SIB 18 02 20

DELIVERY STOP: INSPECT NUTS ON CATALYTIC CONVERTER

This Service Information Bulletin (Revision 2) replaces SI B18 02 20 **dated June 2020**.

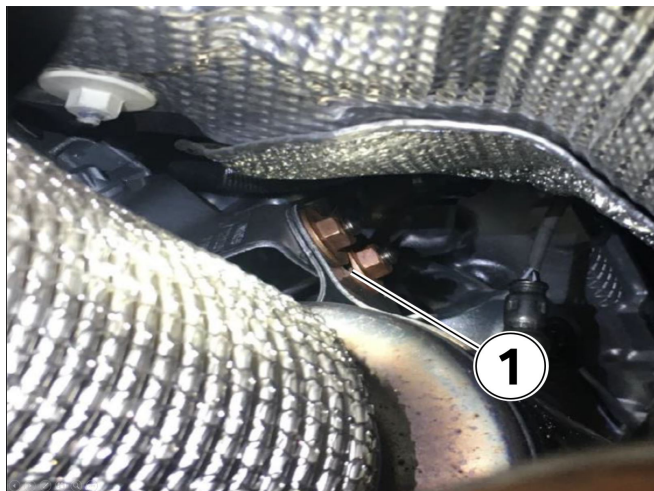
The nuts on the catalytic converter bracket in the engine compartment have been incorrectly torqued (19 Nm instead of 28 Nm).

Check which type of nuts (1) are present on the holder of the catalytic converter and, if necessary, tighten the nuts to proper specification.

Visually check which type of nuts are on the holder of the catalytic converter (1).

If galvanized nuts (1) are installed, no further repairs are necessary.

If copper nuts (2) are installed, remove the air filter housing as described in the Repair Instruction RA 13 71 000 Remove and install intake silencer housing to access the nuts.

Tighten the existing copper nuts to 28 Nm.

- Do not replace the copper nuts
